Addendum 01

PROJECT: Jennings County Entrance Security Renovations
34 West Main Street
North Vernon, Indiana 47265

PROJECT #: 25064.00

This addendum form is a part of the Contract Documents and modifies the Construction Documents dated March 26, 2026, with amendments and additions noted below.

4 FIRST FLOOR REFLECTED CEILING PLAN - UNIT A
1/4" = 1'-0"

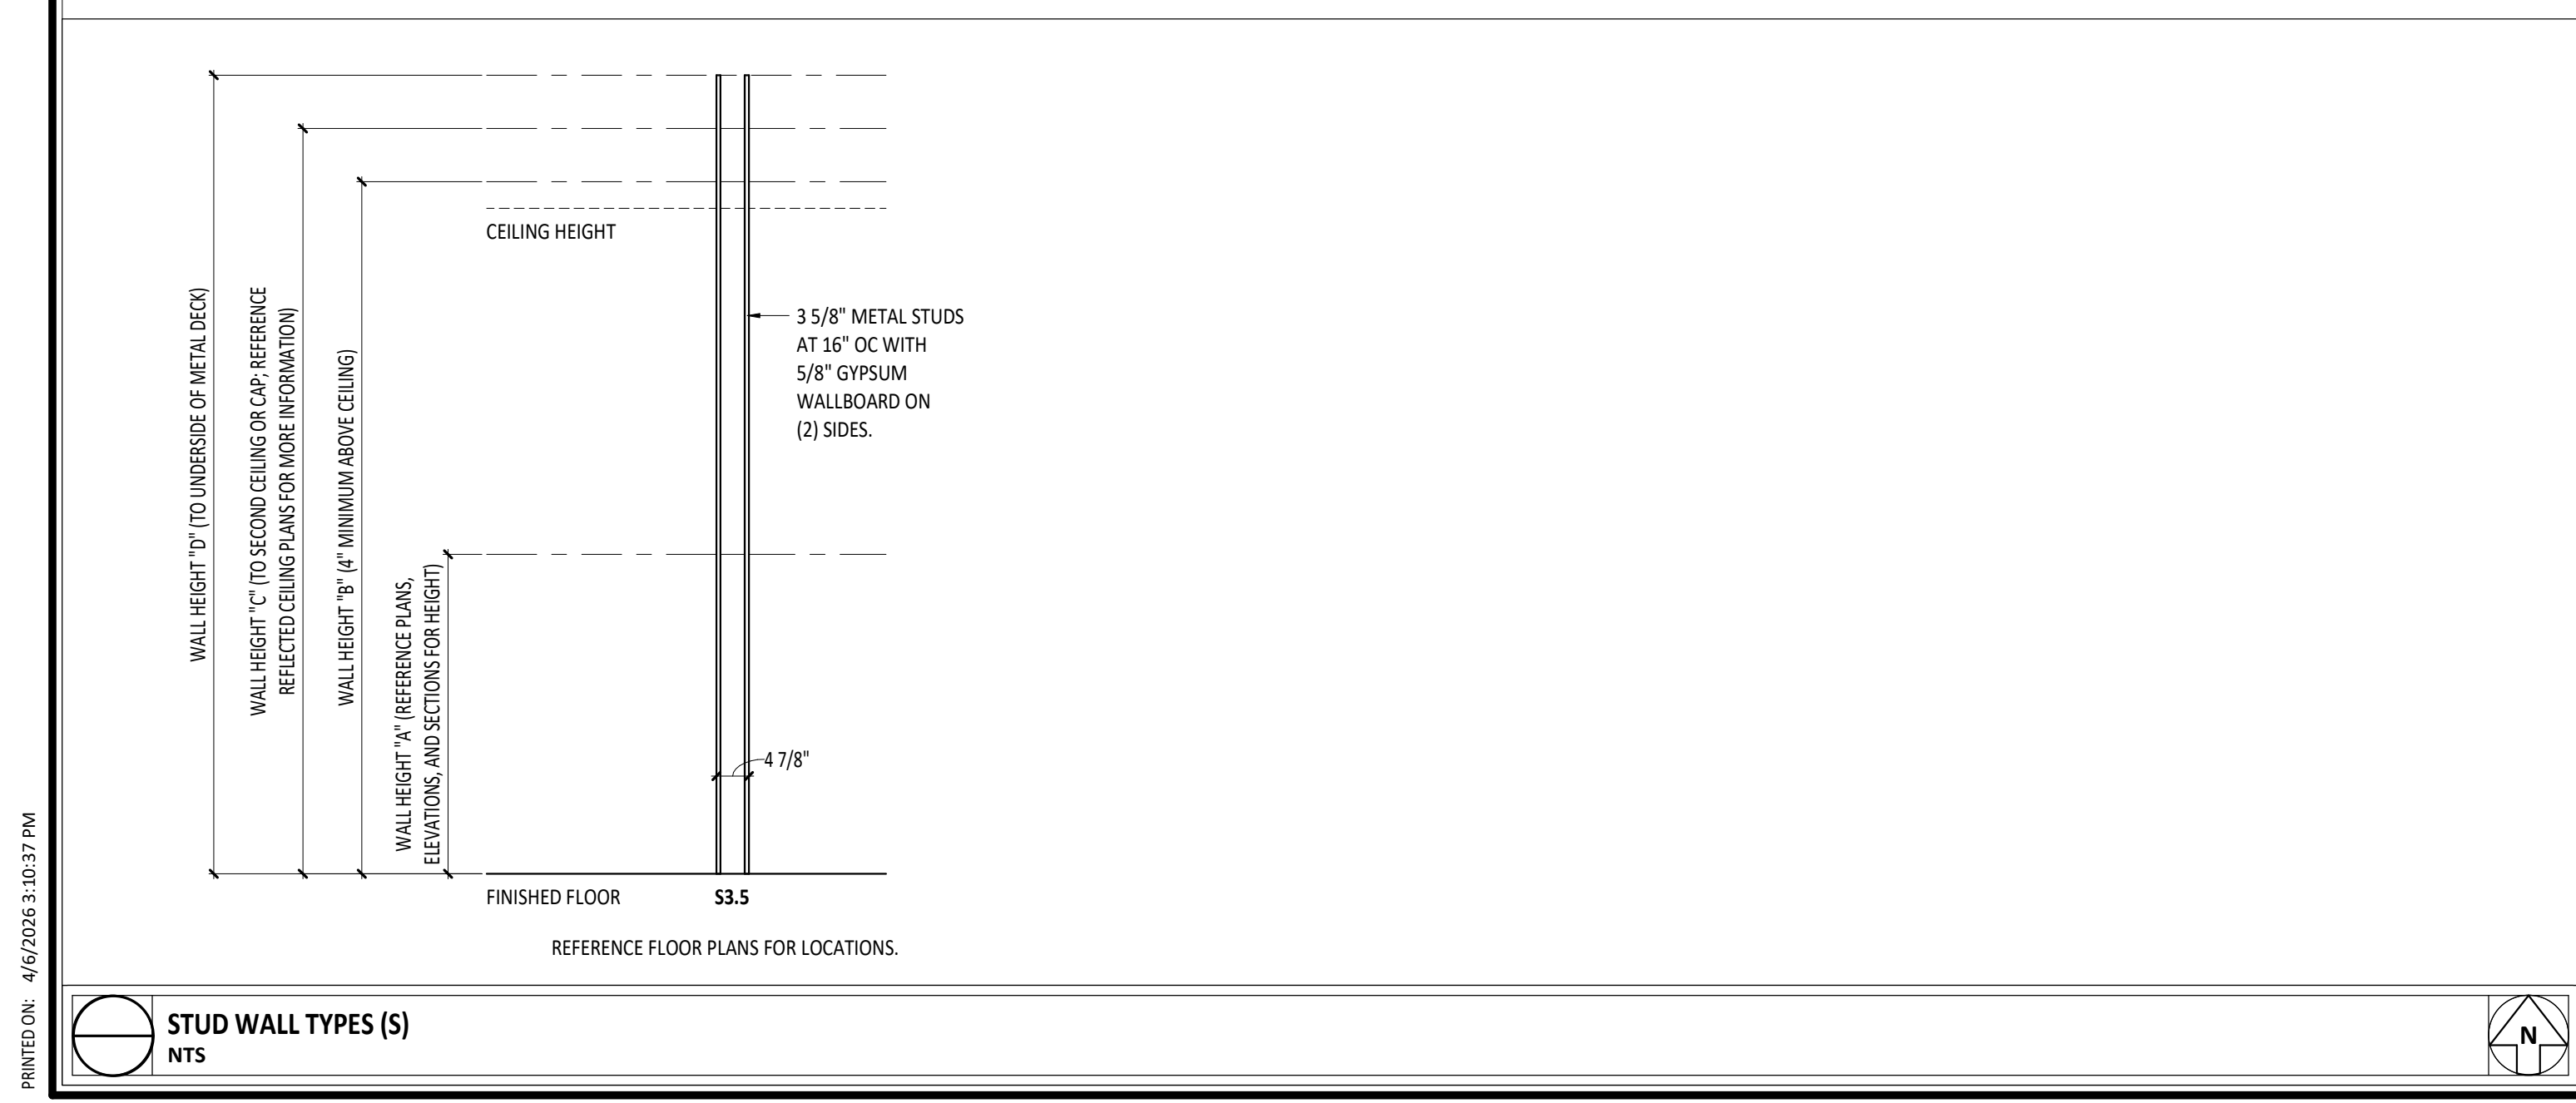
1. Drawing Sheet BC-A1.1 Architectural Plans
 - a. Revise ceiling demolition notes to keynote 02 41 00.14
 - b. Revise all ceilings as shown in detail #4 to by type D.

SHEET NUMBER:
H-ET2.1

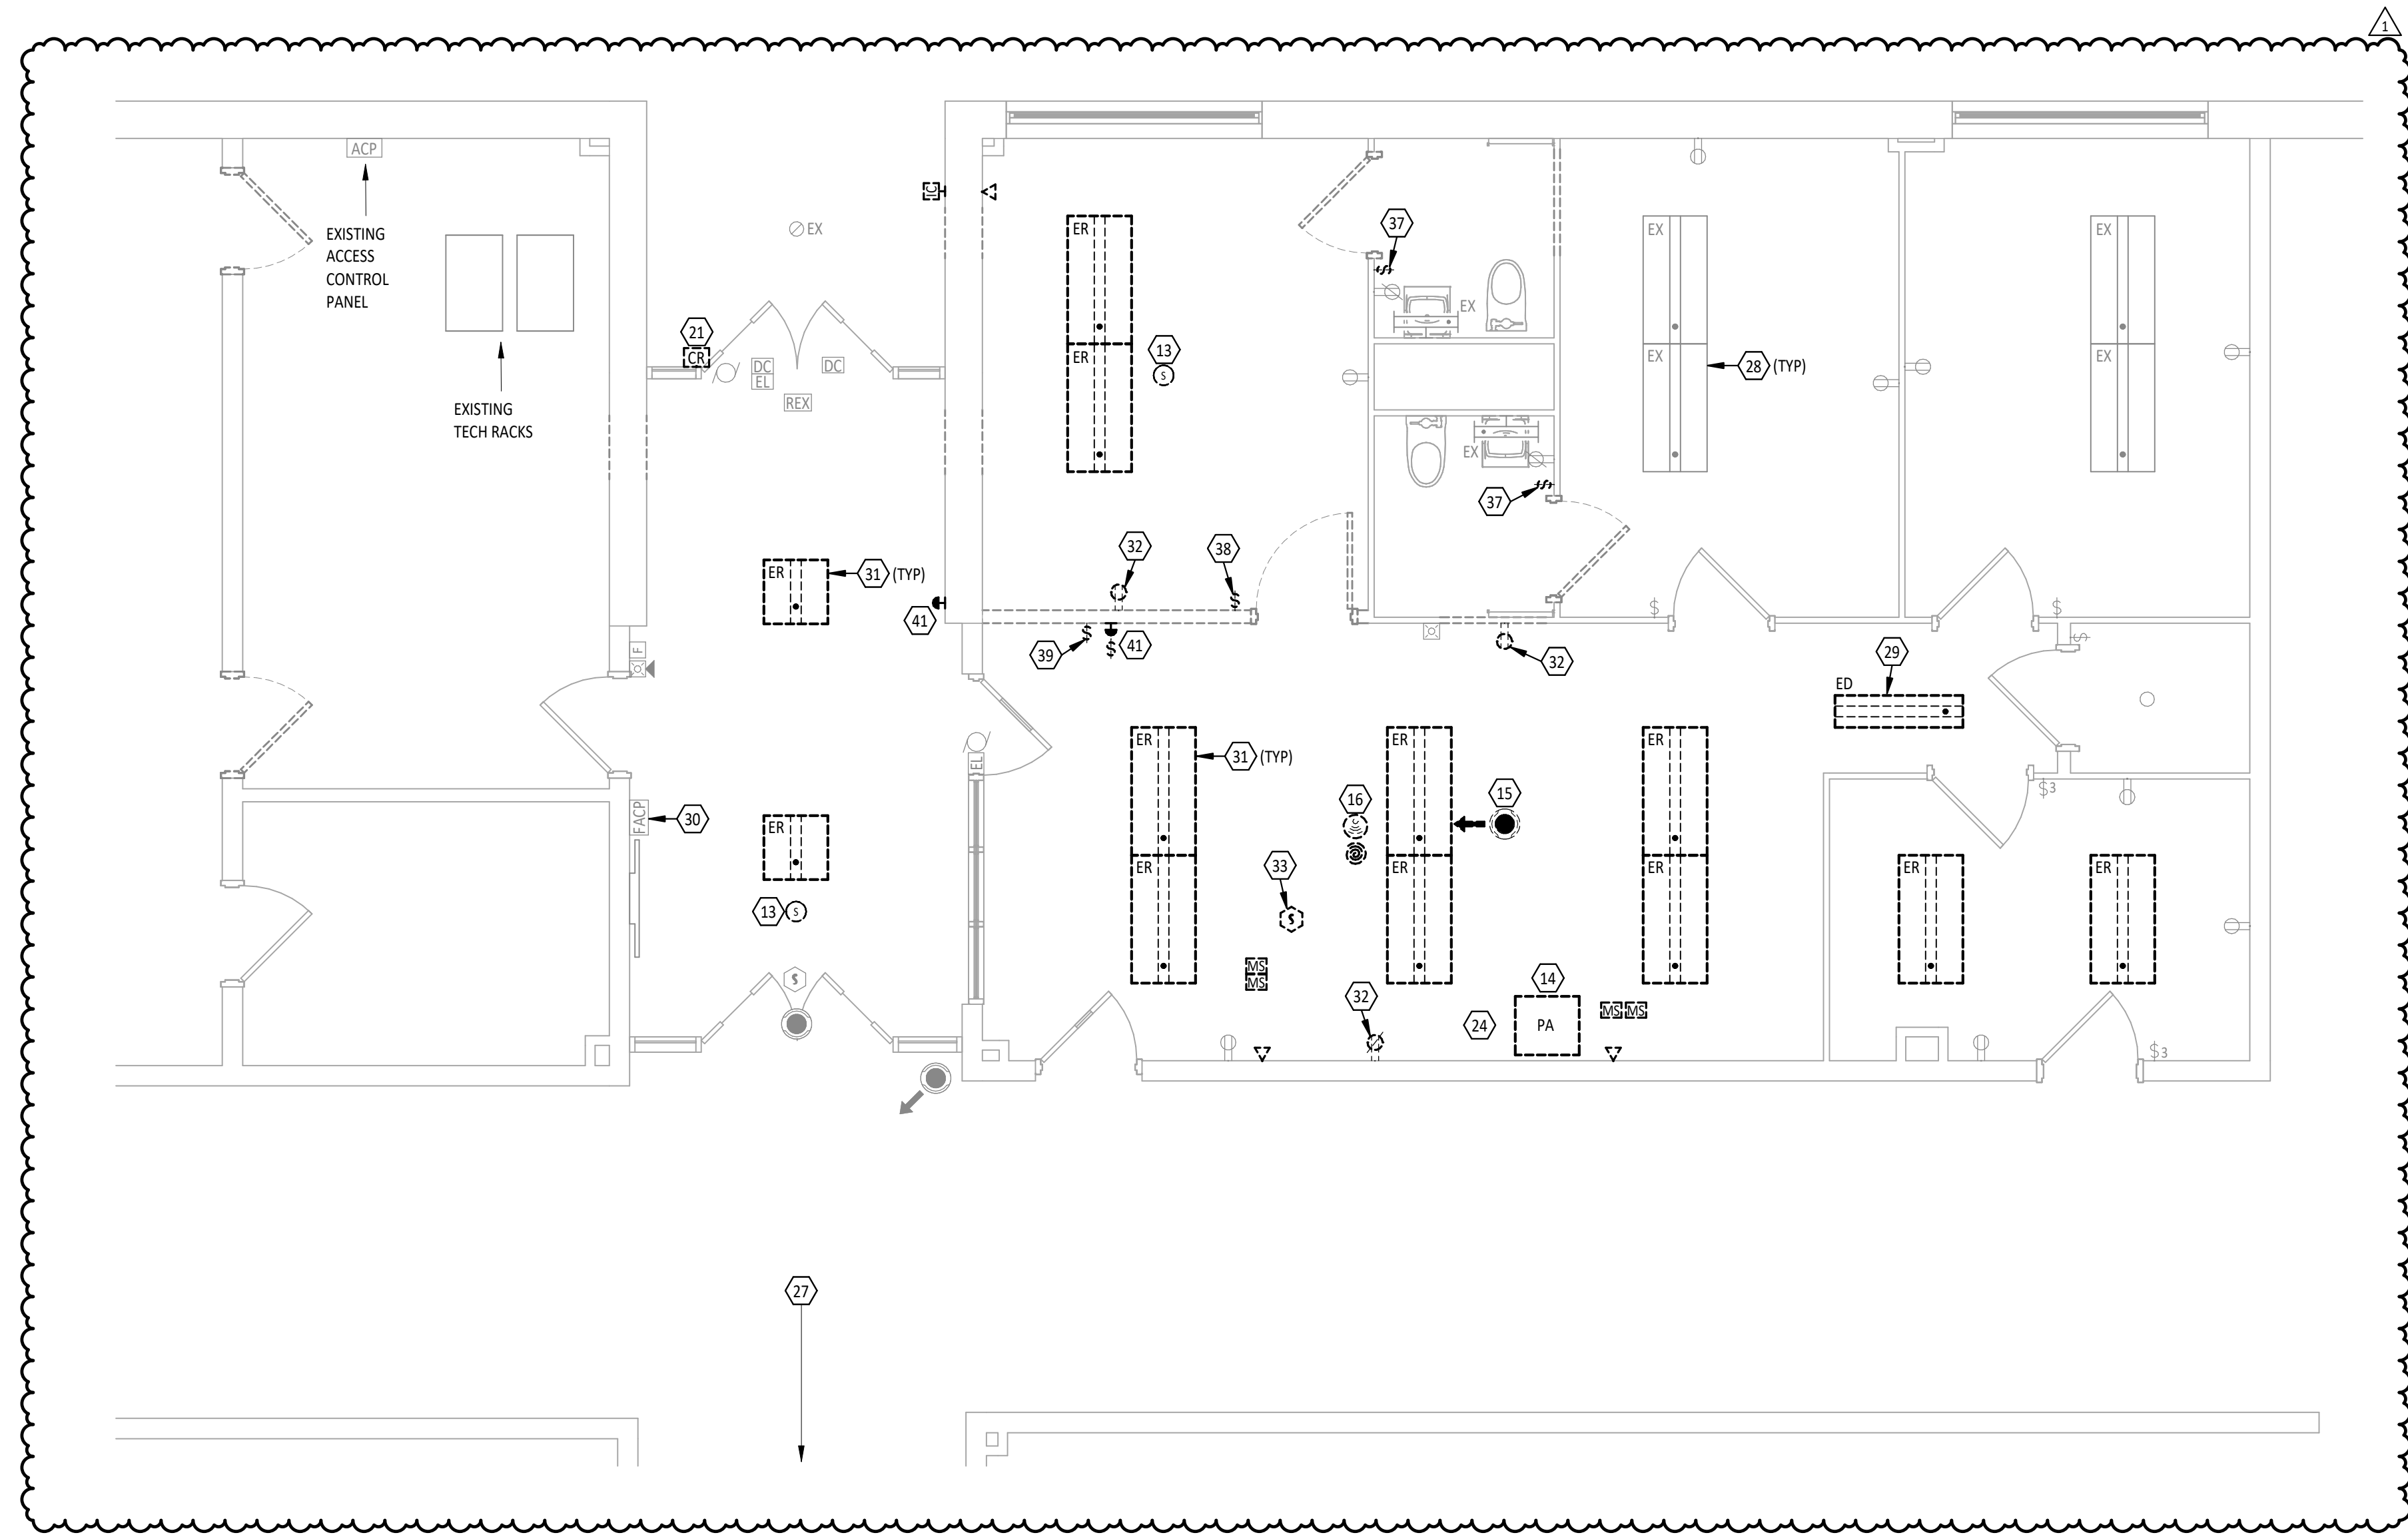
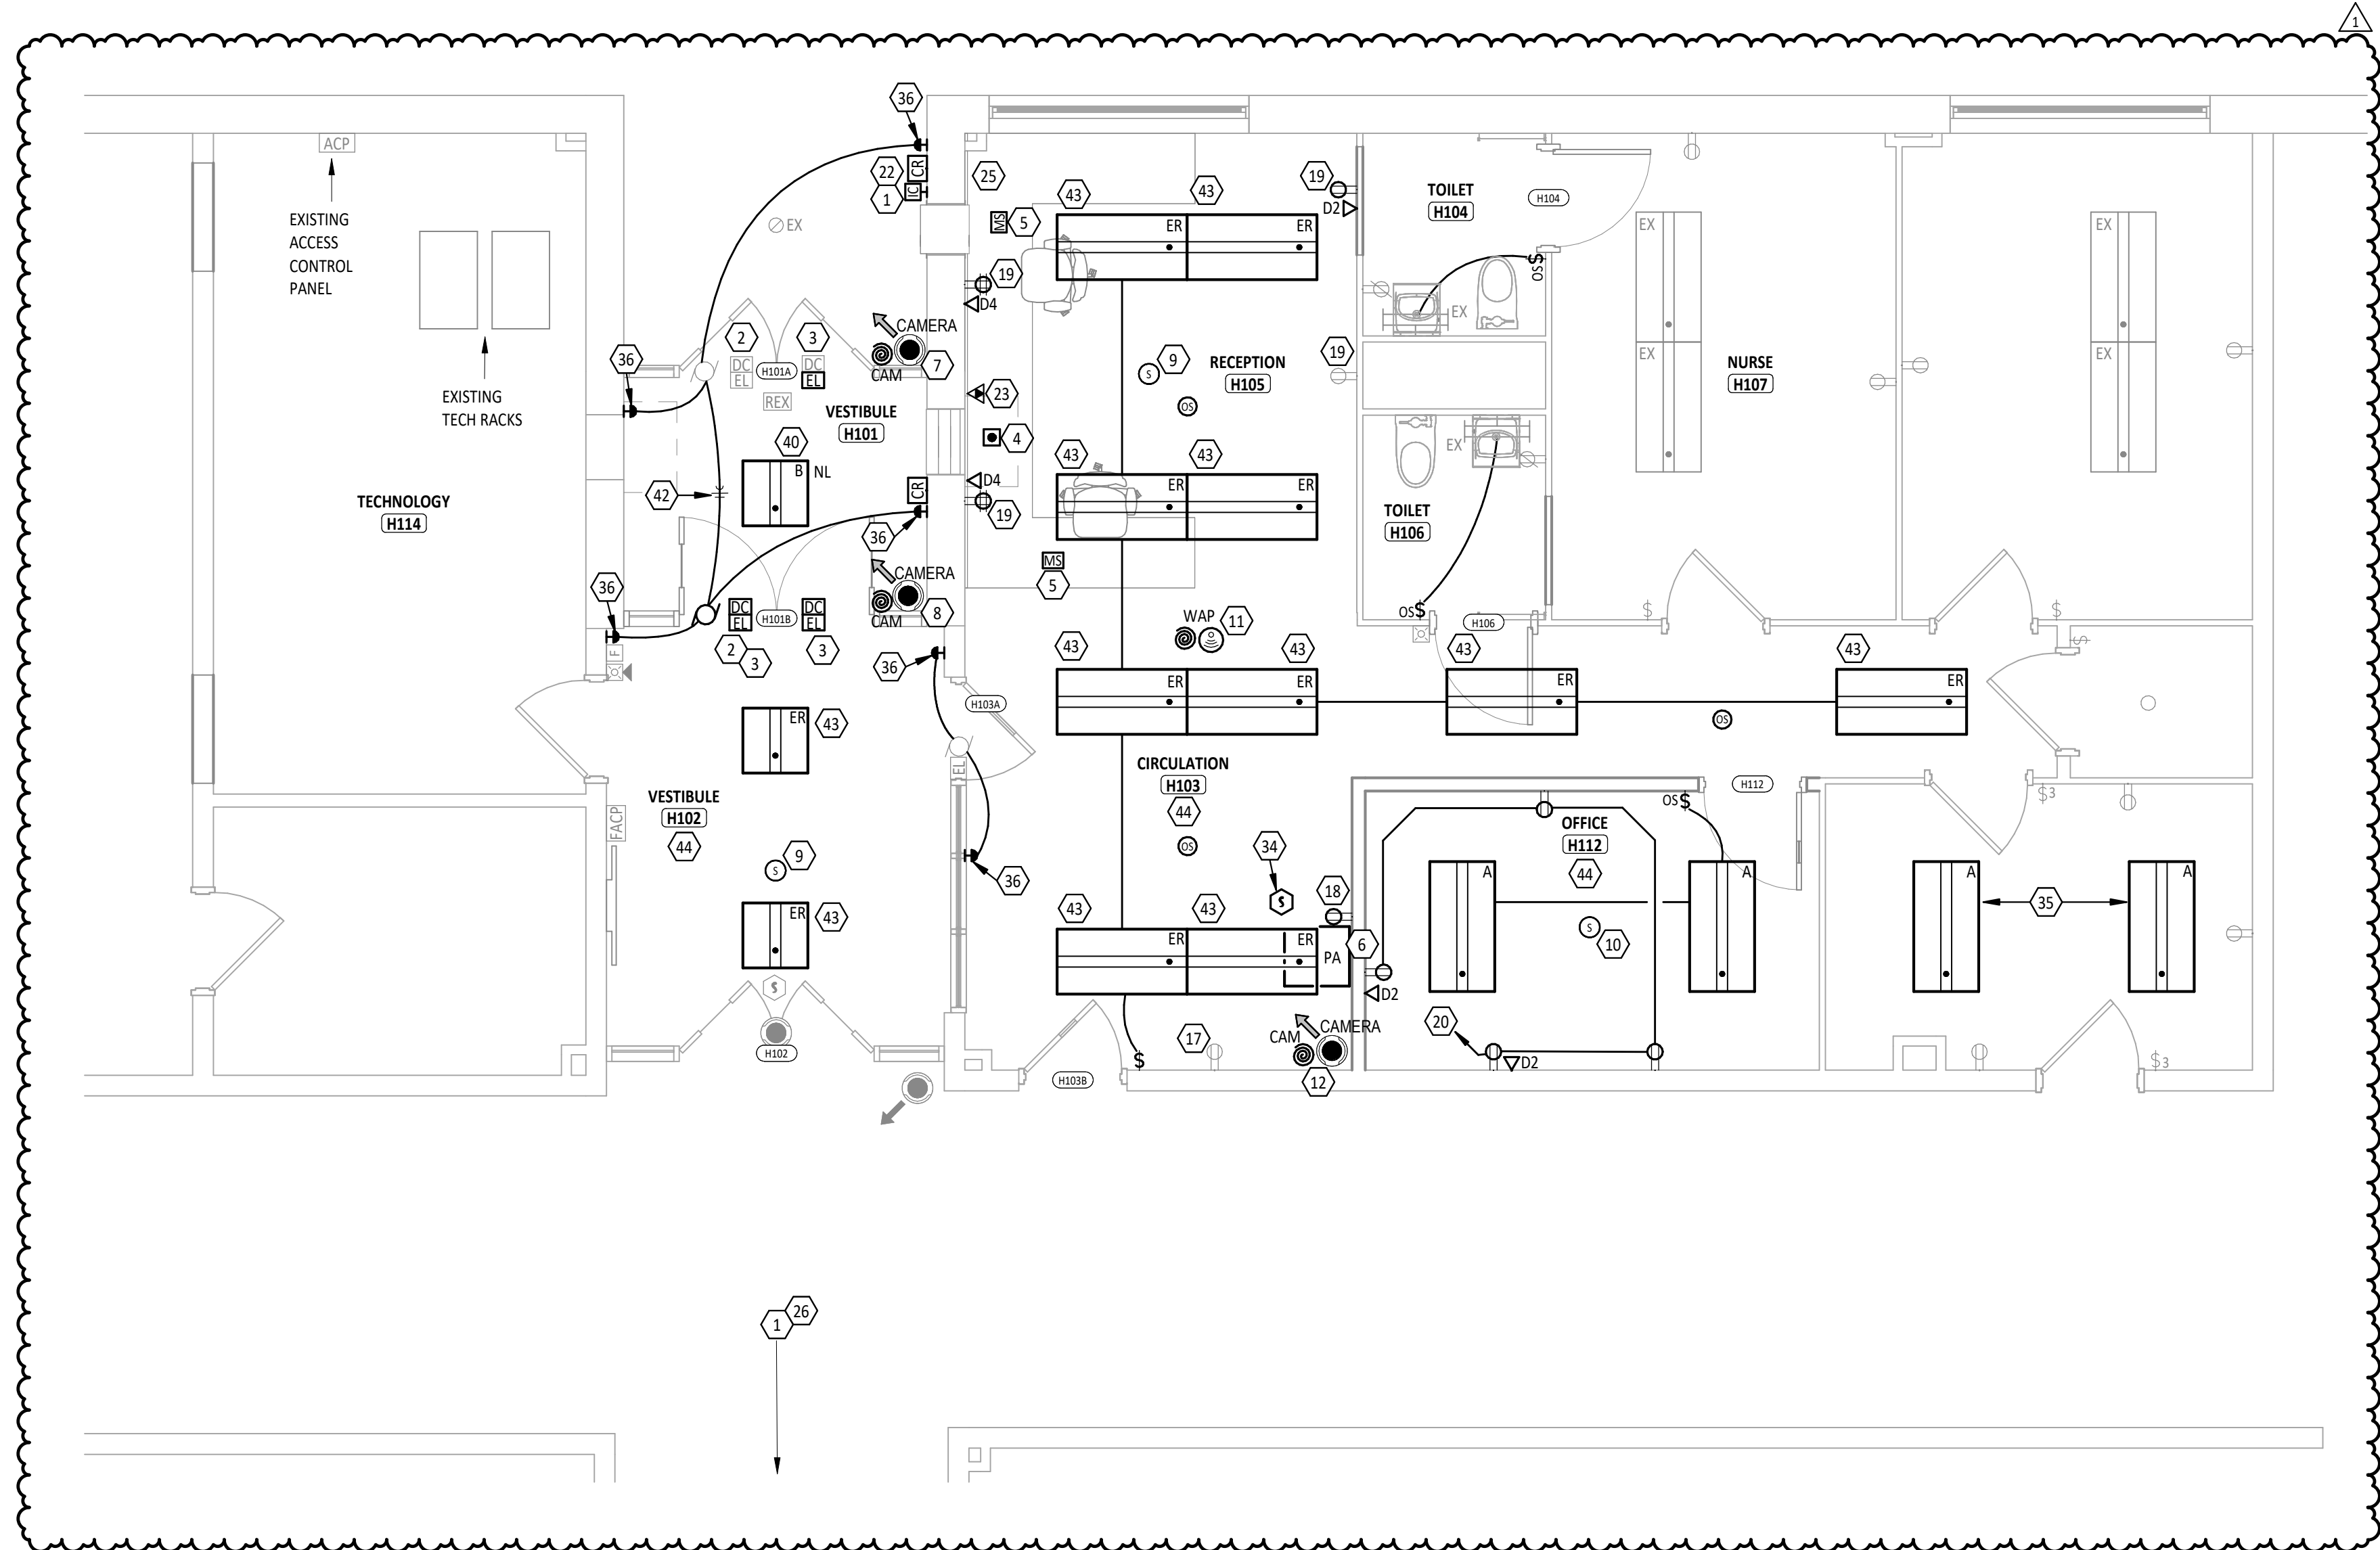
2. Drawing Sheet H-ET2.1 Electrical and Technology Plan:
 - a. Add tags to existing light fixtures to indicate scope of work. "EX" lights to remain, "ER" lights to be salvaged for reinstallation, "ED" shall be removed.

- b. Add keynotes 28 through 44.
 - c. Added circuit lines to light fixtures to clarify switching/circuitry.
 - d. Add clarification in Office H112 that (1) added 120V circuit is required for new receptacles.

- e. Remove (1) light switch at door H103b.
3. Drawing Sheet SC-ET2.1 Electrical and Technology Plan:
 - a. Revise verbiage of keynote 9.
 - b. Add Fire Alarm General Notes.
